To: All Prospective Bidders
From: Patricia A. Peshka, Purchasing Agent
Date: May 20, 2020
Re: **Bid 2020-313 Buckeye Brook Restoration Project**

Addendum #1

**CITY OF WARWICK, RHODE ISLAND
BUCKEYE BROOK RESTORATION PROJECT
BID 2020-313
ADDENDUM NO. 1
20 May 2020**

DATE: APRIL 2020
PROJECT NUMBER: 63293.01
C-107
SHEET: 9 OF 12

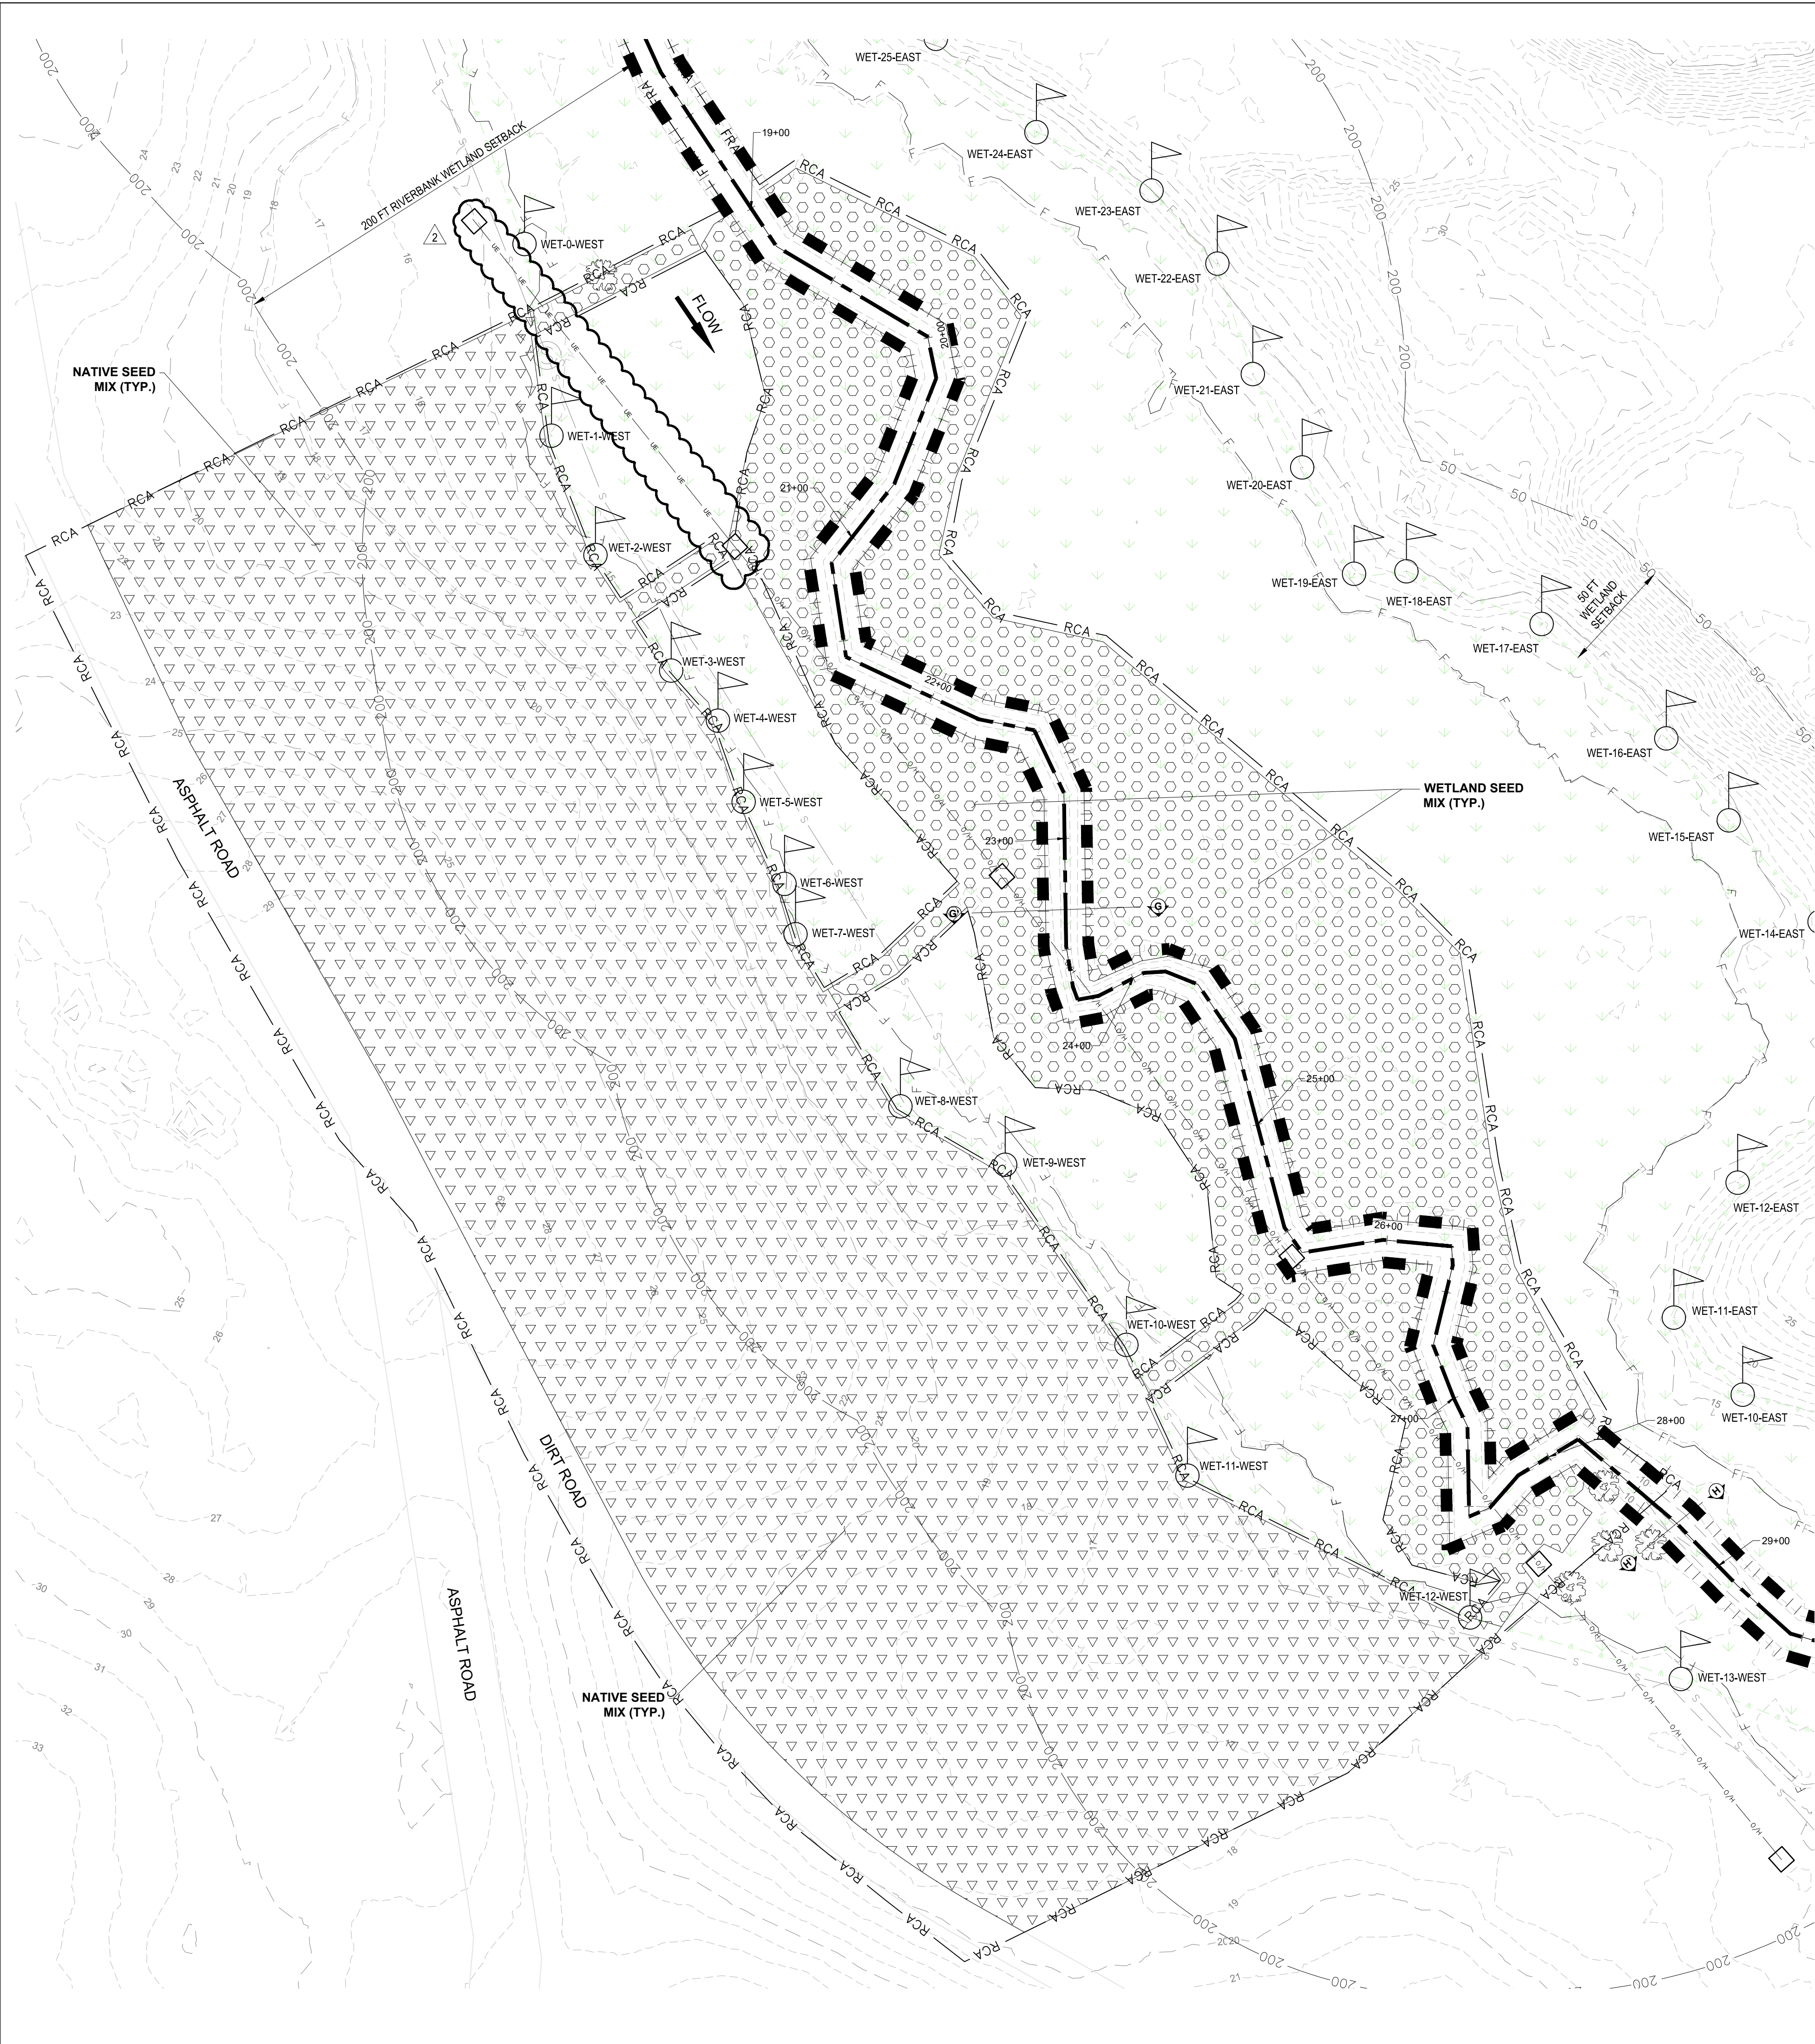
19. In cross section detail for the dewatering area cells the temporary structure appears to be on flat ground. There is up to a 6' grade difference on plan view. Will any grading need to take place prior to the installation of the dewatering basin? If not, will this design hold the weight of the wet excavated soils?

Response: The contractor will need to provide for temporary site grading to install the dewatering basins, and then restore the site at the completion of the project. The dewatering areas can be located anywhere within the RCA

DATE: APRIL 2020
PROJECT NUMBER: 63293.01
C-108
SHEET: 10 OF 12

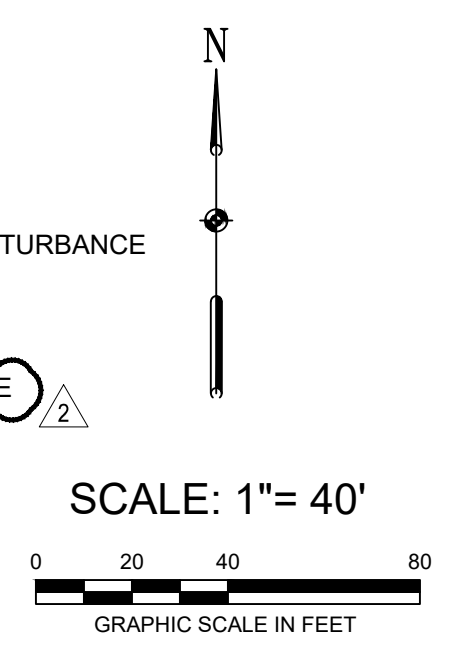
15. Comment: The native seed mix table in the drawings do not add up to 100% by weight. The spec book also references RIDOT M.18.10.6 Native Seed Mix. This also does not match the drawings with respect to Perennial Ryegrass and Fescue % by weight.

Response: The table on the drawings has been updated to reflect the RIDOT M. 18.10.6 Native Seed mix.
16. Comment: Where do the straw bales go?
Response: The straw bales are an optional erosion and sediment control measure for the contractor to use if necessary.
